**ALBEMARLE COUNTY PLANNING
STAFF REPORT UPDATE**

PROJECT: SP201800016 Ecovillage Charlottesville – Preserved Steep Slopes
MAGISTERIAL DISTRICT: Rio
TAX MAP/PARCEL(S): 06100000021000
LOCATION: Rio Rd E, between Brookway Drive and Rockbrook Drive; existing addressed structures on the subject property(s) include 480 Rio Rd E.
PROPOSAL: Disturbance of preserved steep slopes to accommodate the development of private facilities (entrance, accessway, and parking) for the proposed “Ecovillage Charlottesville” residential development.
PETITION: “Private facilities on preserved slopes” pursuant to Zoning Ordinance (Z.O.) Section 30.7.4.b.2.
ZONING: R4 Residential, which allows residential uses by right (4 units per acre).
OVERLAY DISTRICT(S): Airport Impact Area; Steep Slopes – (Managed) and (Preserved).
COMPREHENSIVE PLAN: “Neighborhood Density Residential” which calls for residential use (3–6 units/acre) and supporting uses such as religious institutions, schools, and other small-scale non-residential uses; in the Development Area in Neighborhood 2 (Places 29).

DETAILS OF THE PROPOSAL – REVISIONS (resubmittal materials received 2/4/2019):

"Area of Revisions" exhibit - page 8 of "Supplementary Exhibits" packet (Att. G) – showing revised location of commercial entrance, revised configuration of parking area, and revised alignment of private street accessway.

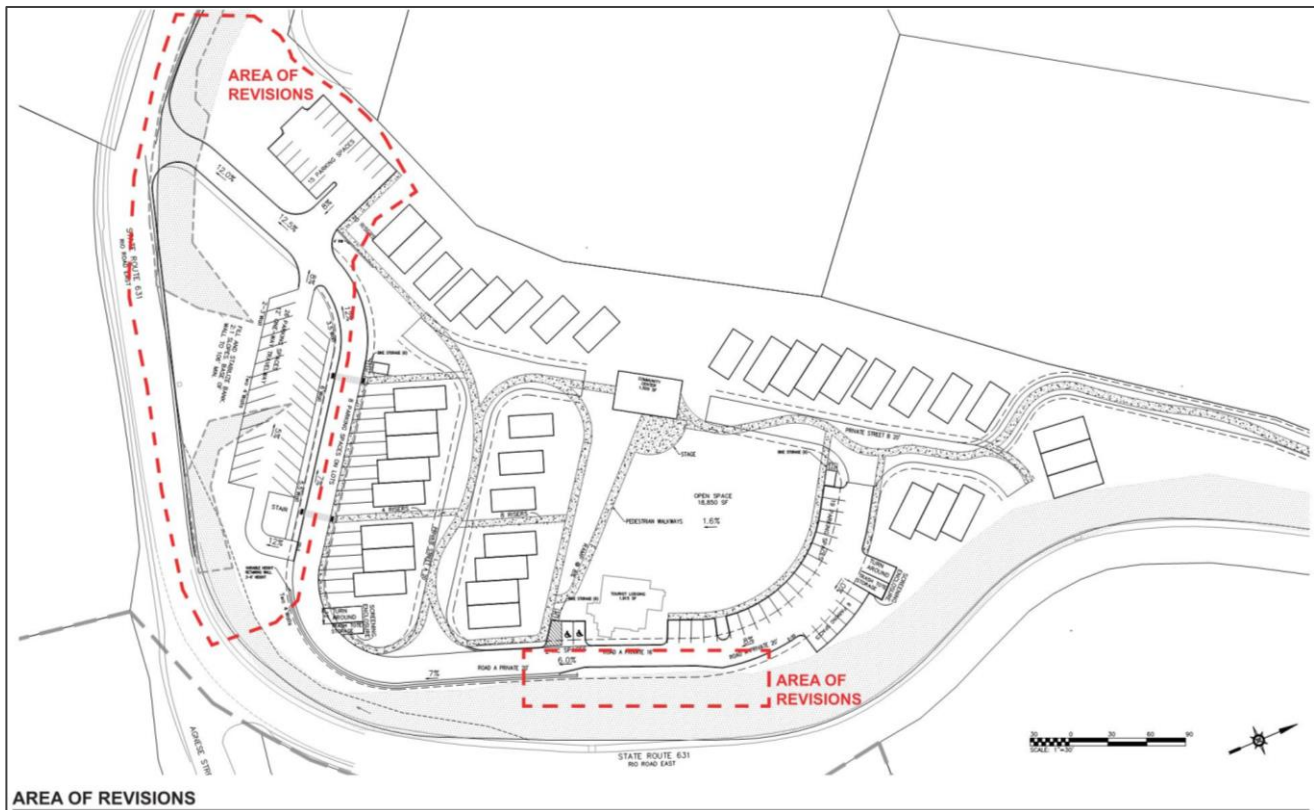
Issue 3 update: In lieu of continuing the ongoing waiver request process with VDOT, the applicants' resubmittal materials include revisions to the location and design of the proposed new commercial entrance private facility that would eliminate the need for the VDOT waiver.

An overview of the proposed revisions to SP201800016 is shown in the “Area of Revisions” exhibit (above), which is taken from page 8 of “Supplementary Exhibits” packet (Attachment G). A summary of the proposed revisions to the project proposal follows below.

To accomplish this, the applicants are now proposing to shift the location of the proposed new commercial entrance approximately 50 feet to the west (downhill), and also proposing disturbance of preserved steep slopes in an area along Rio Road East which was not previously proposed. More specifically, the applicants now propose grading (cutting) the preserved steep slopes along Rio Road East to the east (uphill) of the proposed new entrance, as this additional cut would be necessary to provide adequate sight distance towards the westbound traffic coming downhill towards the proposed new entrance.

Detail of "Habitat Planting Plan" and "Landscape Schedule" (Att. H) with a revision date 2/26/2019; compare to page 26 of "Supplementary Exhibits" packet (Att. G) dated 2/4/2019.

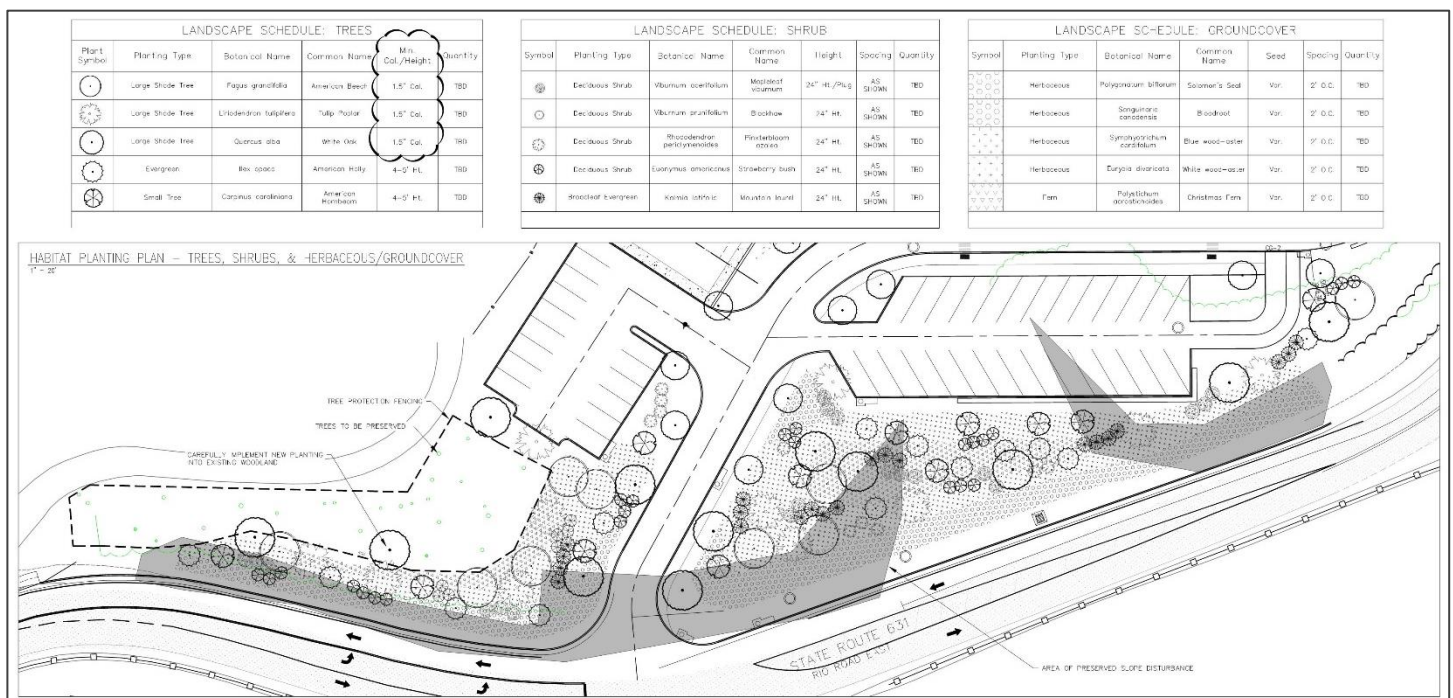
However, the mitigation techniques shown on the planting plan are conceptual in nature. This conceptual level of detail makes it difficult to determine if the quantity and locations of proposed landscaping are

sufficient. More specifically, the conceptual level of detail and unspecified quantifications prevent staff from being able to make the following positive findings about the Habitat Planting Plan: that it would sufficiently mitigate impacts to the character of the steep slopes overlay district and nearby area; and that it would sufficiently mitigate the impacts to the ecological and hydrological performance of the existing landscape that would result from the proposed grading and removal of existing vegetation; and that it would provide sufficient screening for the proposed parking area private facility as viewed from Rio Road East. These are all relevant factors to consider when evaluating this proposed special use permit. Please also note that some screening of the parking area is otherwise required pursuant to Zoning Ordinance Section 32 (Site Development Plan), Subsections 32.7.9.5.e (“Landscaping Along Streets – Shrubs along public streets.”) and 32.7.9.7.a.2 (“Screening – Parking areas.”).

Despite the limitations stemming from the conceptual level of detail and quantifications, the new Habitat Planting Plan embodies desirable design concepts and is a strong starting point for addressing replacement landscaping and habitat. However, staff opinion is that additional landscaping is needed in the form of additional evergreen shrubs and evergreen trees at strategic locations in the vicinity of the proposed parking area private facility, in order to ensure sufficient screening of this proposed private facility within the preserved steep slopes overlay district in a way that appropriately mitigates the impacts to the character of the district and nearby area.

Staff also believes that the proposed habitat planting plan should be further revised to include a certain number of plant materials to be specified at a larger height or larger caliper (as applicable) than the minimum required height or minimum required caliper. Staff acknowledges that smaller plant materials may eventually take root and thrive more successfully over time than plant materials which are larger, taller, or have larger root balls at the time of planting. However, plant materials that are larger at the time of planting would significantly help to provide more immediate mitigation of the impacts to the character of the steep slopes overlay district and nearby area. Therefore, staff believes that a certain portion (25% - 33%) of the shrub, understory, and canopy plant materials in the vicinity of the proposed parking area private facility should be specified to be larger than the minimum required height or caliper.

- a. The "Landscape Schedule" for the "Habitat Planting Plan" must be revised so that a certain portion (25% - 33%) of the tree plant materials and shrub plant materials are specified at a minimum caliper or minimum height that, at the time of planting, meets the minimum size requirements for landscaping materials as would be required within the Entrance Corridor.

- b. The "Habitat Planting Plan" must be revised to be supplemented with additional numbers of evergreen shrubs and evergreen trees at strategic locations in the vicinity of the proposed

parking area private facility in order to sufficiently provide screening for this proposed private facility within the preserved steep slopes overlay district. A certain portion (33% - 66%) of these vegetative screening materials in this vicinity shall be specified at a minimum caliper or minimum height that, at the time of planting, meets the minimum size requirements for landscaping materials as would be required within the Entrance Corridor.

Detail of "Proposed Entrance Layout" exhibit (Att. I – revision date 2/27/2019); compare to "Stormwater Improvements" exhibit on page 22 of "Supplementary Exhibits" packet (Att. G) dated 2/4/2019.

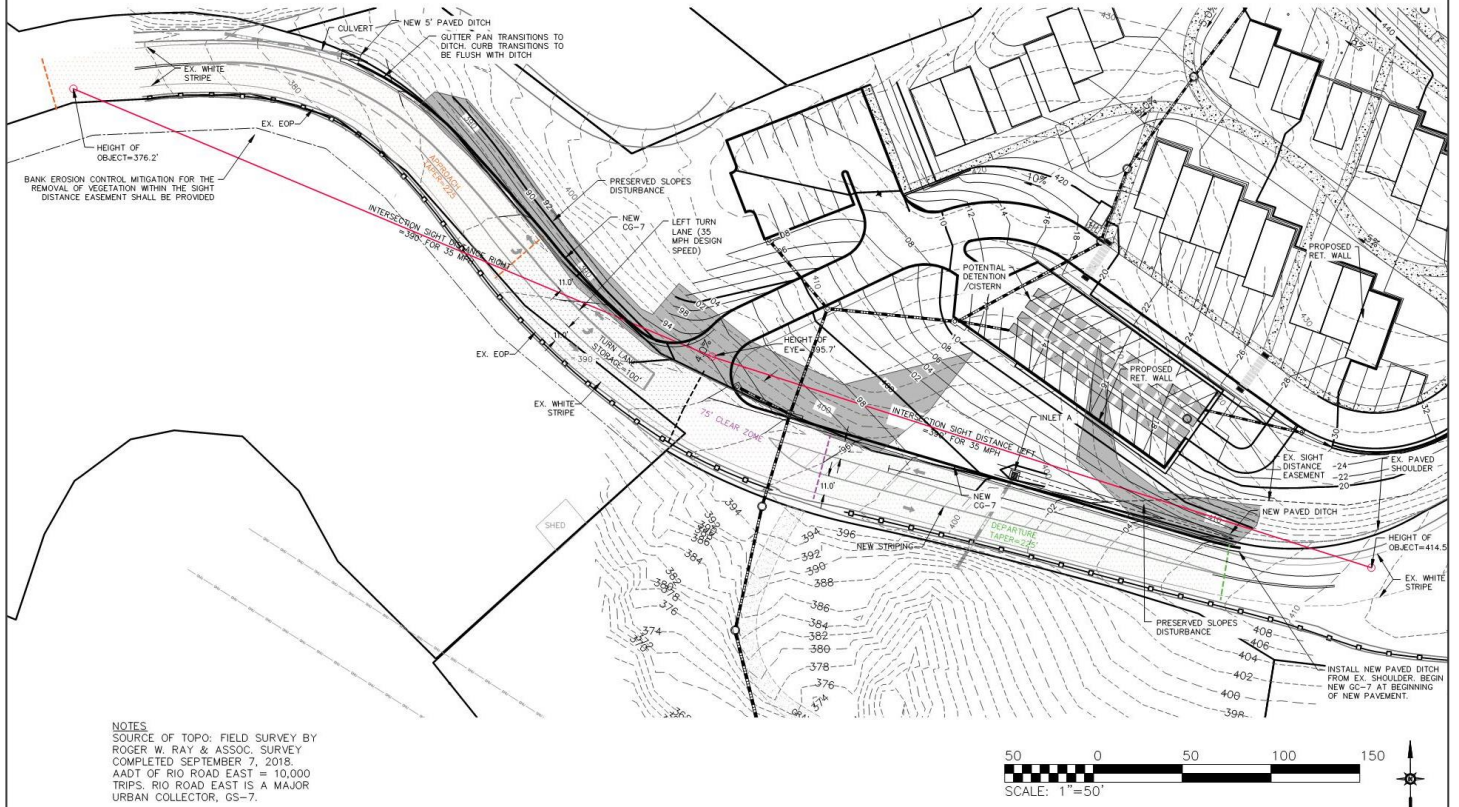
The “Proposed Entrance Layout” exhibit (Attachment I – revision date 2/27/2019), which appears to be an updated version of the “Stormwater Improvements” exhibit on page 22 of “Supplementary Exhibits” packet (Attachment G – dated 2/4/2019), shows the following improvements and other mitigation techniques:

- Reconstruction of the existing paved ditch along Rio Road East to improve drainage;
- Construction of curb and gutter along Rio Road East above proposed entrance to convey stormwater to new inlets that would convey to Meadow Creek;
- Construction of curb and gutter along Rio Road East below proposed entrance to convey stormwater to a new paved ditch above existing culvert; and
- Implementation of off-site “bank erosion control mitigation” proposed in conjunction with the removal of existing vegetation within a proposed sight distance easement.
- (Note: A “potential detention / cistern” feature is also shown underneath the proposed parking area private facility on Att. I. This feature, if implemented, would primarily manage stormwater runoff from the development located above the preserved steep slopes, possibly for reuse by Ecovillage.)

Mr. Pohl indicated that the conceptual plans, exhibits, and other information contained in the resubmittal application materials represent an appropriate combination of mitigation techniques, provided that certain important details are properly addressed (finalized) during future review processes for a Final Site Plan and Water Protection Ordinance Plan. Mr. Pohl's concerns and recommendations relate to the following:

- The importance of providing treatment of stormwater (for water quality) on-site;
- The importance of proposed grading not including any slopes in excess of 33% grade;
- The importance of using a 25-year design storm (instead of the conventional 10-year design storm); and
- Detailed comments relating to the location and design of stormwater and drainage improvements.

- a. All modified or newly constructed slopes will have a grade that does not exceed a 3:1 slope.
 - b. Drainage improvements along Rio Road East will be designed to manage the 25-year storm event without flooding.

- c. Curb inlets will be provided on both sides of the new entrance to collect site runoff before it enters the Rio Road East right-of-way.
 - d. The specific materials and practices for the proposed "off-site bank erosion control" will be approved by the County Engineer.
